Re: Award of Construction of the former MRI Space at City Hall

MRI Re-fit / City Hall

Dunwoody City Hall Renovations

Demolition Plan

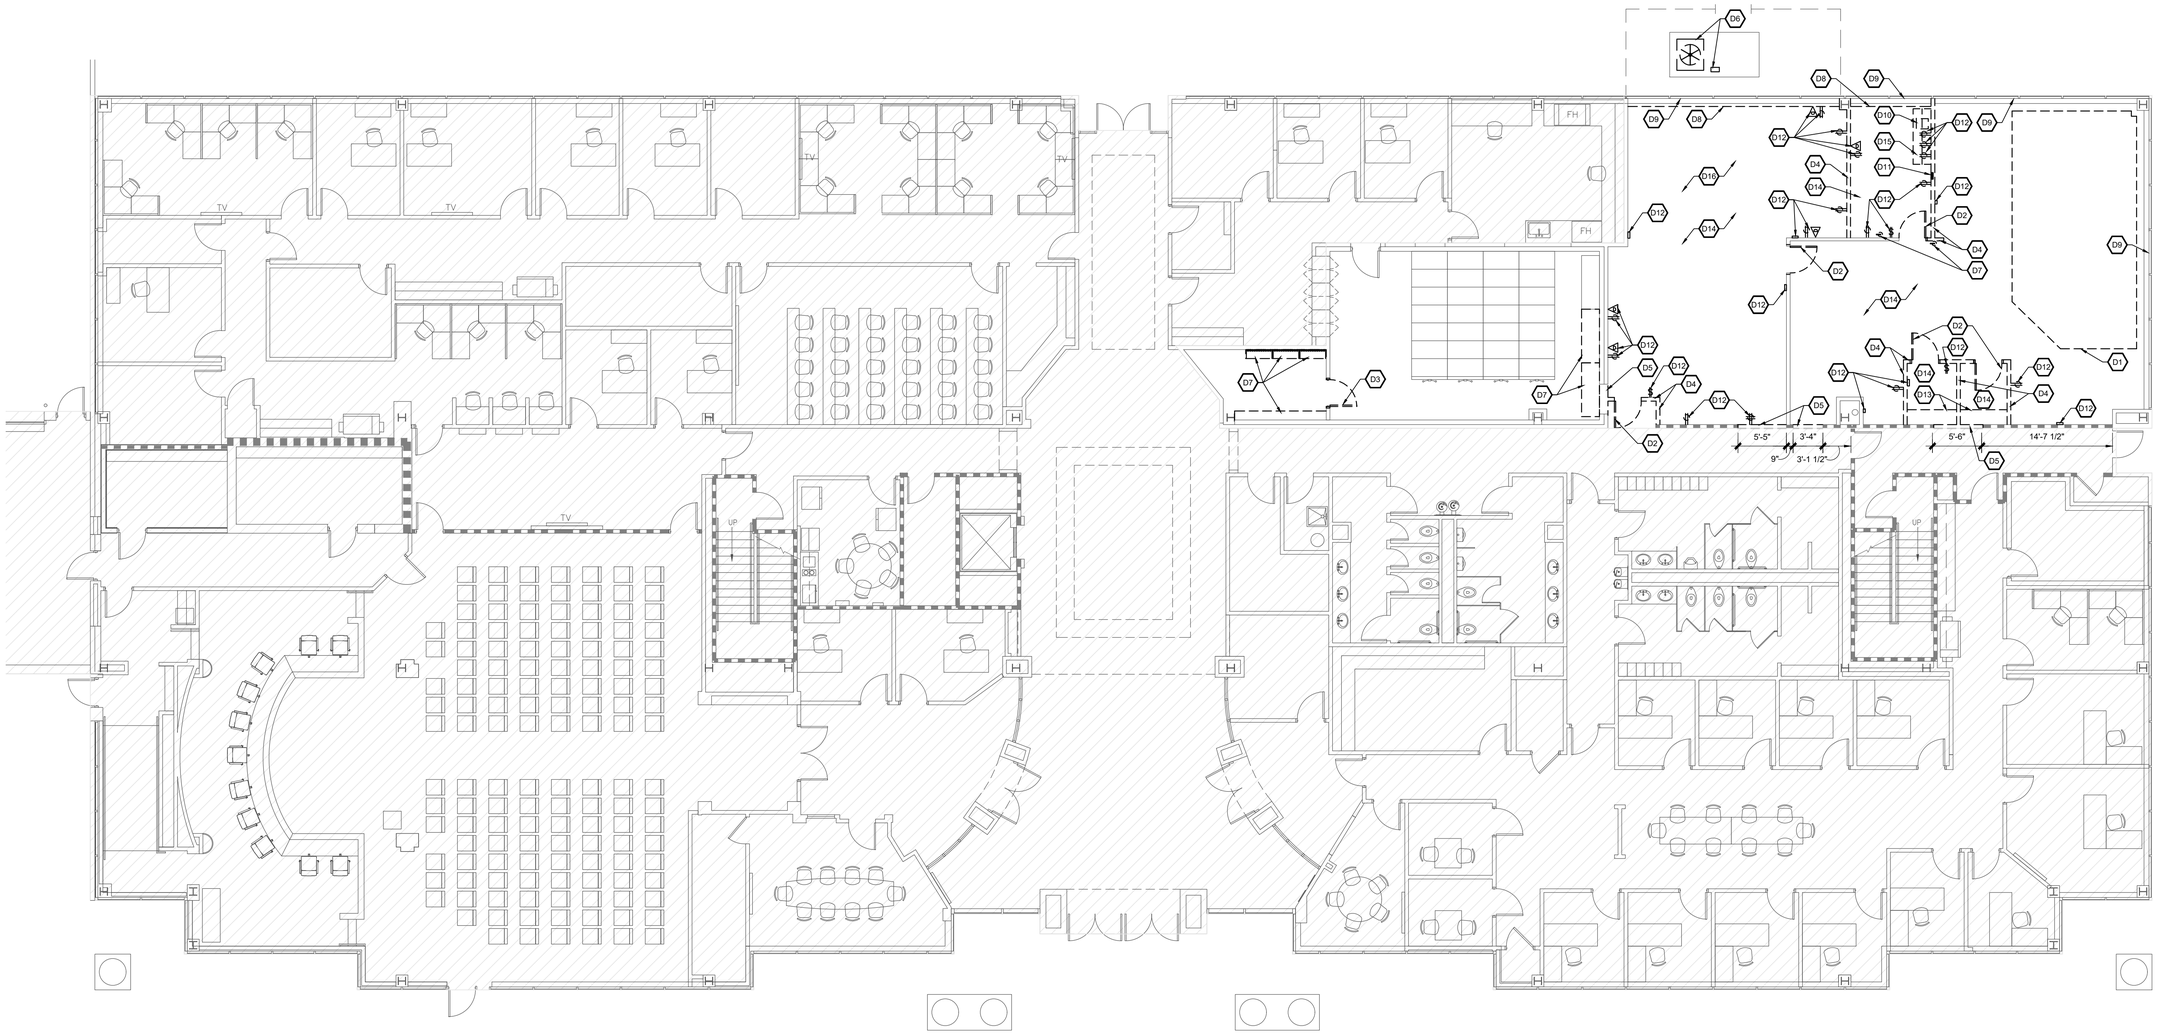
52. Demolition D2.1 Note D7 in existing storage area. Is handling of the storage racks in the GC scope of work? If so, confirm the racks will be unloaded and reach for break down prior to GC mobilization. **The racks will be unloaded and stored by the Owner.**

1 / A2.2 **Reference Plan**

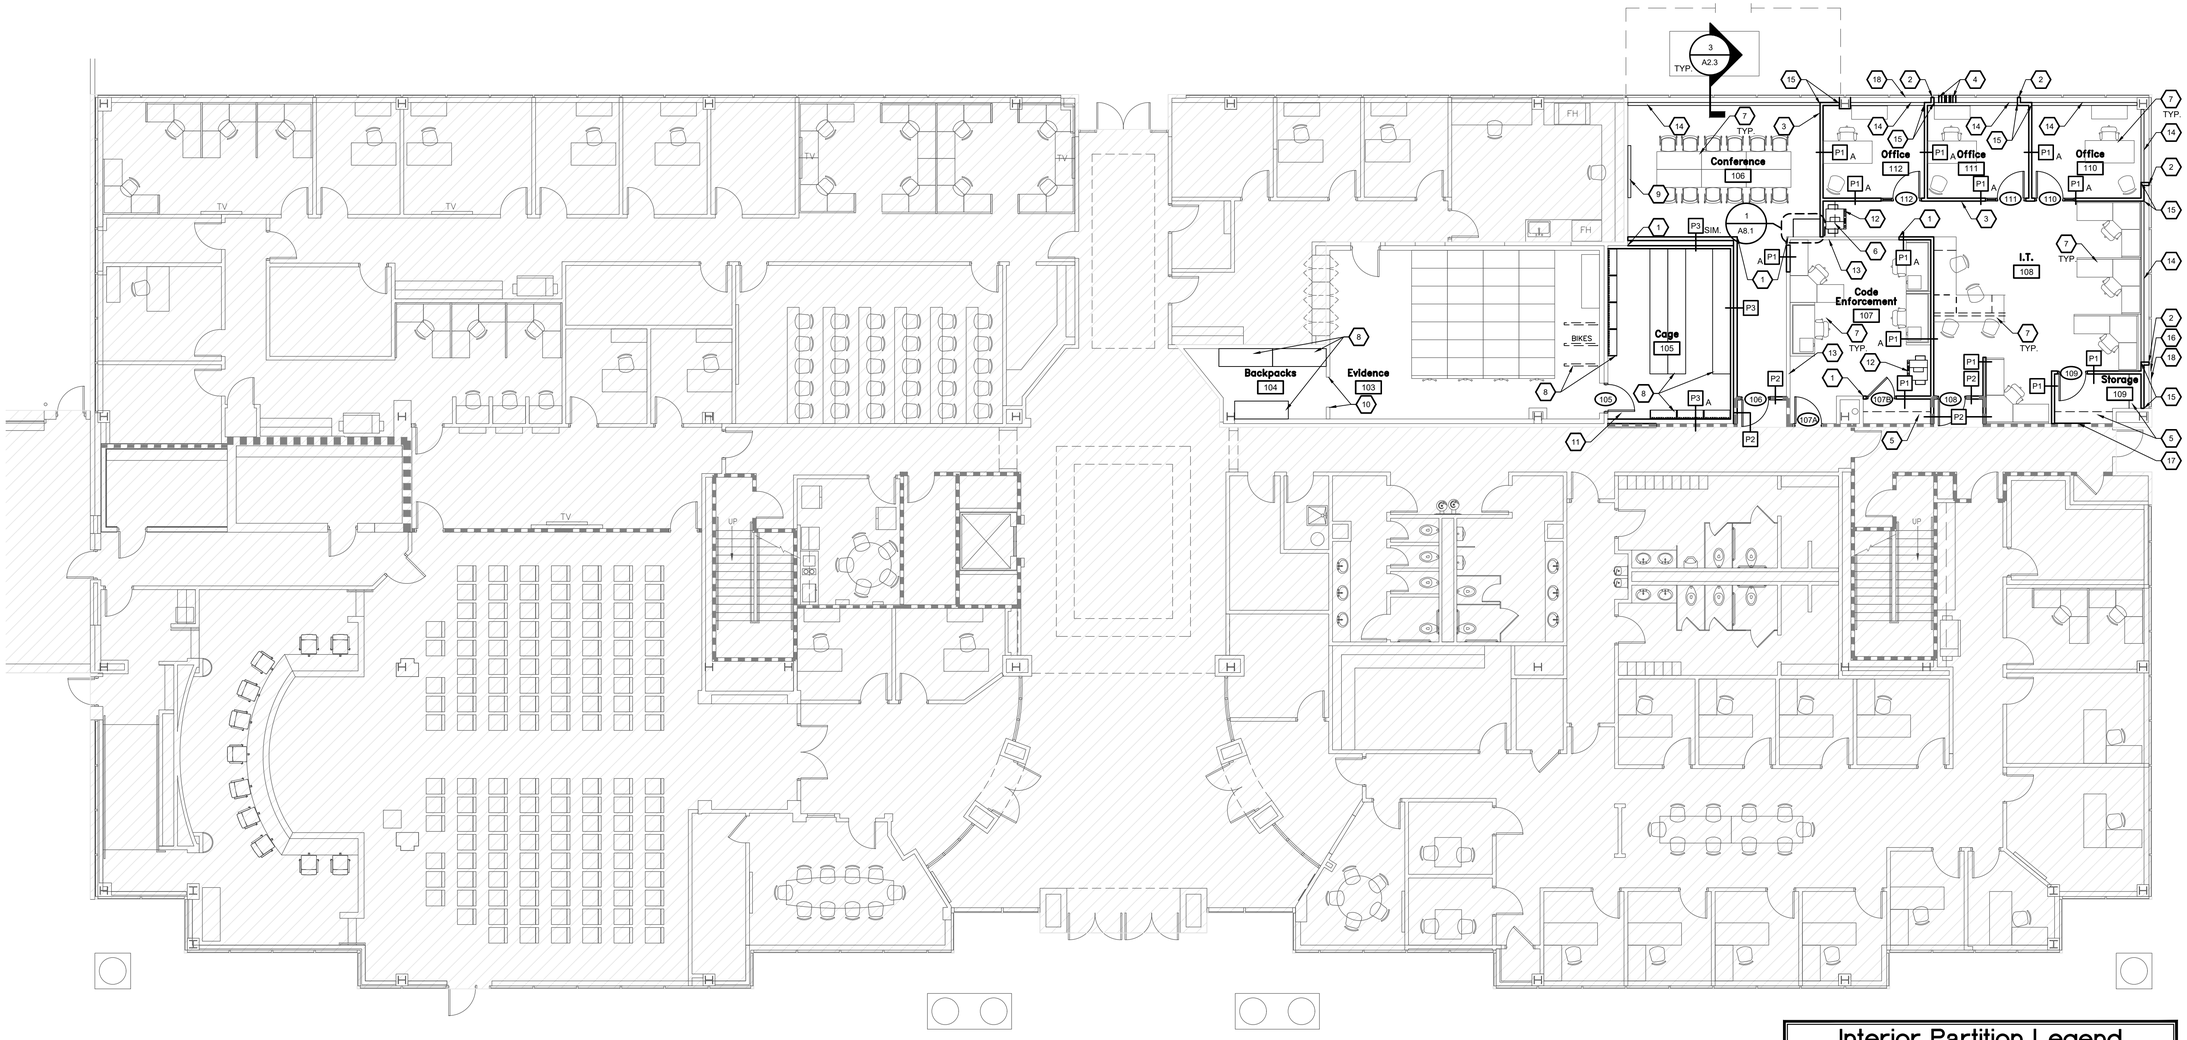
7. Please confirm that new concealed fire treated wood blocking will be required to be installed at plan keynote 5, on drawing A2.2, within the existing fire-rated partition. **The blocking will not be required.**

8. Advise if concealed fire treated wood blocking will be required at plan keynote 8 on drawing A2.2 be required, within the exiting walls. **No, these are storage racks sitting on the floor, not wall mounted shelving.**

11. Please provide specifications of owner furnished/contractor installed furniture, per plan keynote 7 on drawing A2.2. **The Owner has not selected the furniture yet. This will be done during construction. The vendor providing the furniture will furnish & install. This is removed from the contractor’s scope.**

1 A2.3 **Sound Wall Details**

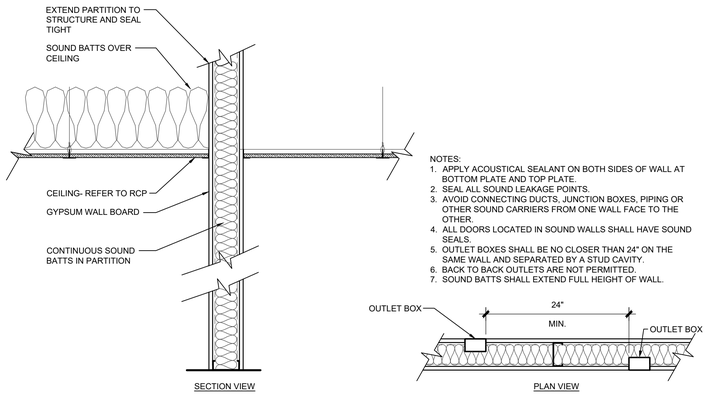
21. Clarify which partitions (see drawing A2.3, detail 1/A2.3) are to be considered a “sound wall” and will require “sound seals” on any doors (see detail 1/A2.3-note 4) within a sound wall. **Refer to sheet A2.2. The walls are tagged as “P1A”.**

Door and Frame Elevations

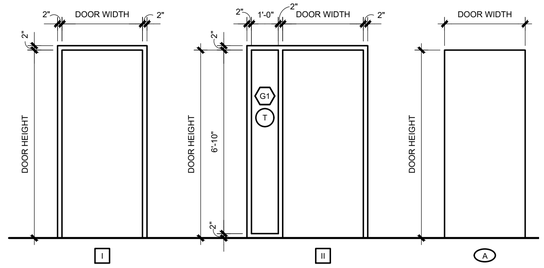
16. Confirm the glass at side light within frame 110 111, 112 is both tempered glass and insulated glass. See drawing A9.1, detail 1/A9.1. **Yes, they are both tempered and insulated.**

1 / A10.1 — **Finish Plan**
SCALE 1/8" = 1'-0"

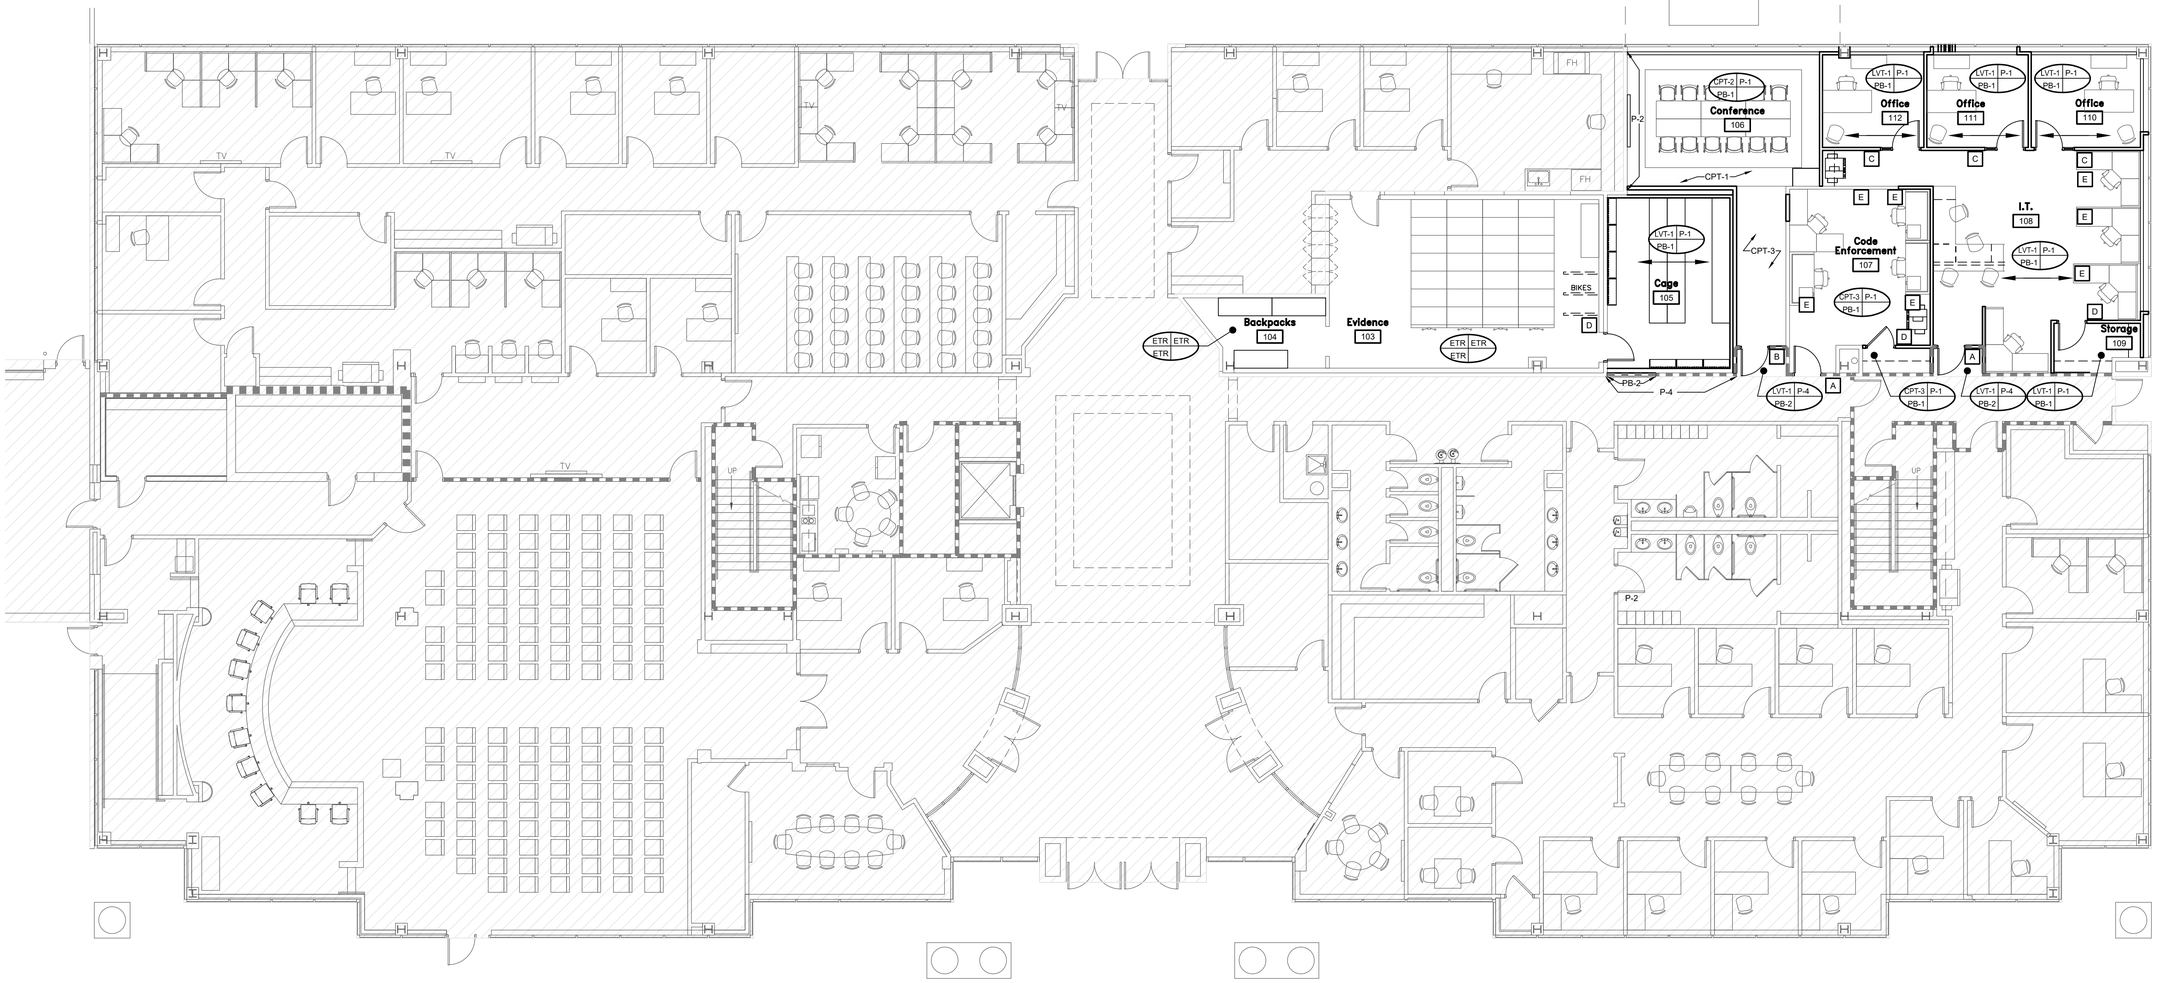
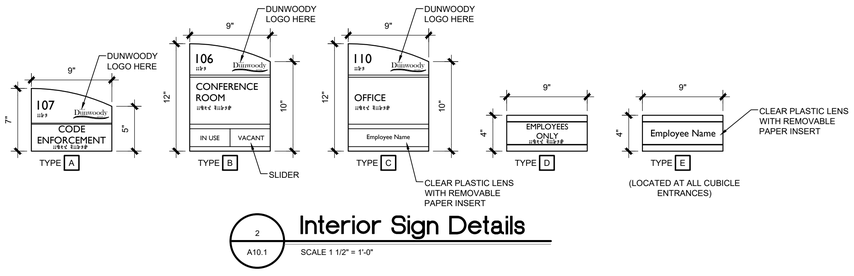
40. Please provide the specified paint color(s) per the finish schedule. **The Manufacturer and paint colors are called out on the finish schedule on sheet A10.1.**

56. A 10.1 Finishes - 2/A10.1 note elevations for signage. Will the signage be in the GC's scope of work? If so, is there a required/preferred vendor? Please provide company name, contact number/email. **Yes. Custom Signs Today Attn: Heyward 404-853-5000, 404-853-5005, signsatlanta@gmail.com**

57. A 10.1 Finishes - The demo drawings notes remove of blind at specific locations, that align with drywall window infills/black out film. Please confirm if the balance of the blinds will remain or be replaced. **All existing window blinds will be removed and disposed of in the renovated area. Blackout film is only required at one location where the window will be completely blocked off by new framing. All the other existing windows and the new door sidelights will receive new window blinds. Refer to General Finish Note #7 on sheet A10.1.**

1 FLOOR PLAN - PLUMBING
1/4" = 1'-0"

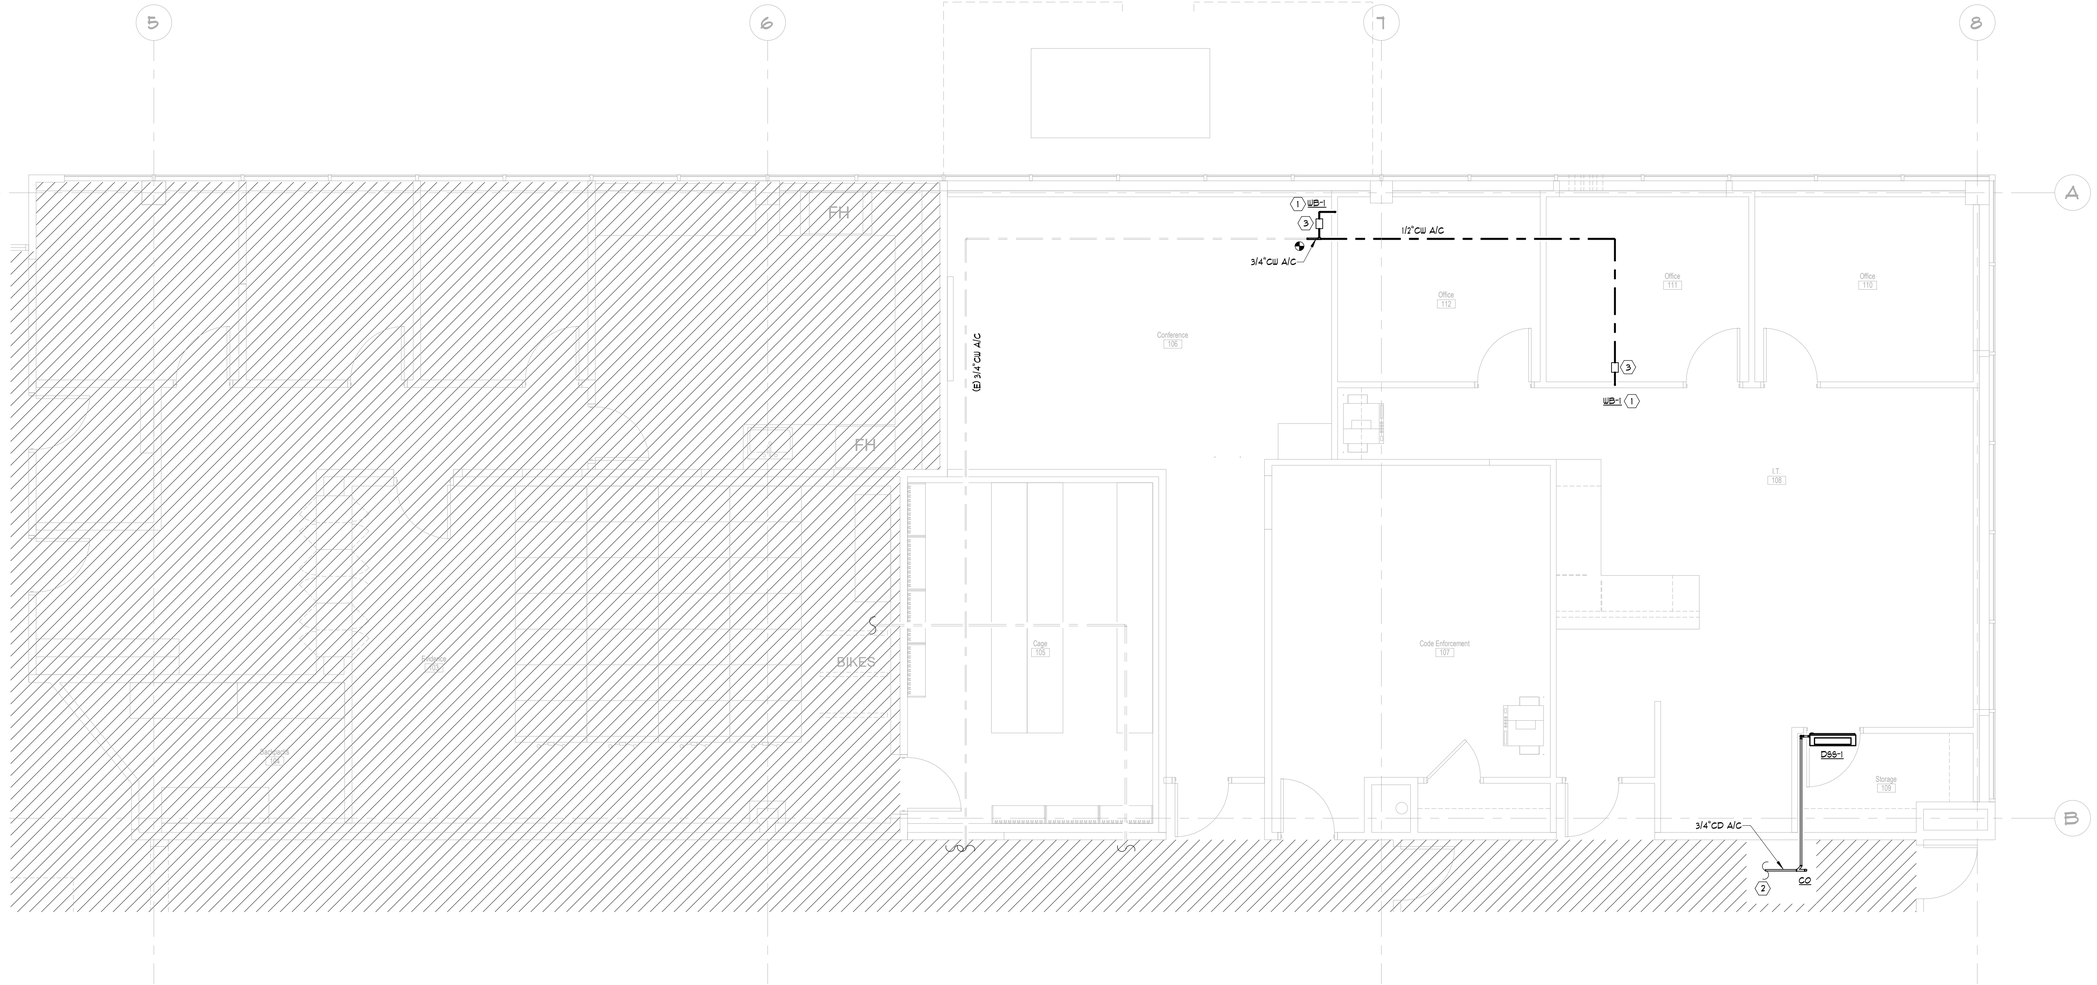
12. Please indicate location of existing “mop sink for dumping of A/G condensate, as per drawing P2.1(keynote 2). **It is shown on the plans in an existing janitors closet across the hallway from Backpacks #104.**
